# SERVICE BULLETIN

**Date:** MARCH 1, 2011  
**Log Number:** 123  
**Models Affected:** EST-44/ EST-66  
**Subject:** EST-44/66 POWER CONNECTION

**DISPENSER POWER BLOCK 208-240V**

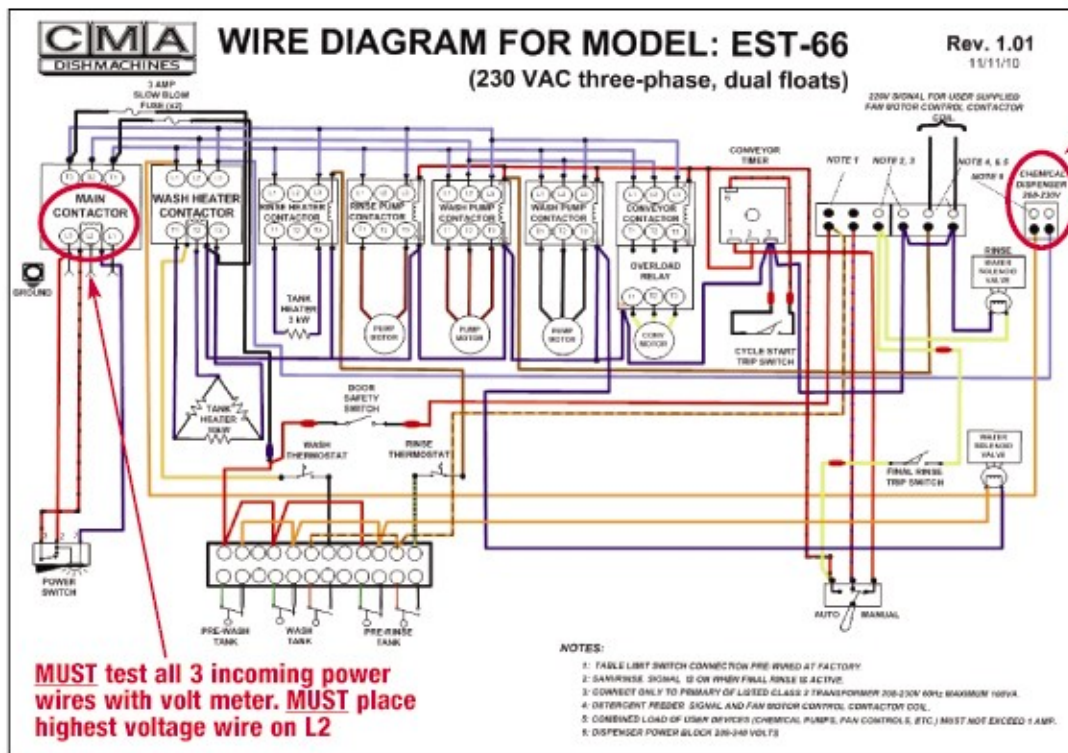
**MUST test all 3 incoming power wires with volt meter. MUST place highest voltage wire on L2**

To prevent excessive overloads and component damage, it is essential for dispenser power supply to be wired to supplied power block on all EST-44 and EST-66 Conveyors. The CMA supplied power block, for your dispenser, has been prewired to the wash heater contactor L1 and L3 terminals, to assure correct and balanced power to the dispenser and surrounding components. It is most important that, if the 3-phase power supply from the facility has a Hi-Leg (wild leg), it must be connected to L2 to prevent overloading the contactor coils.

**MUST test all 3 incoming power wires with volt meter. MUST place highest voltage wire on L2**
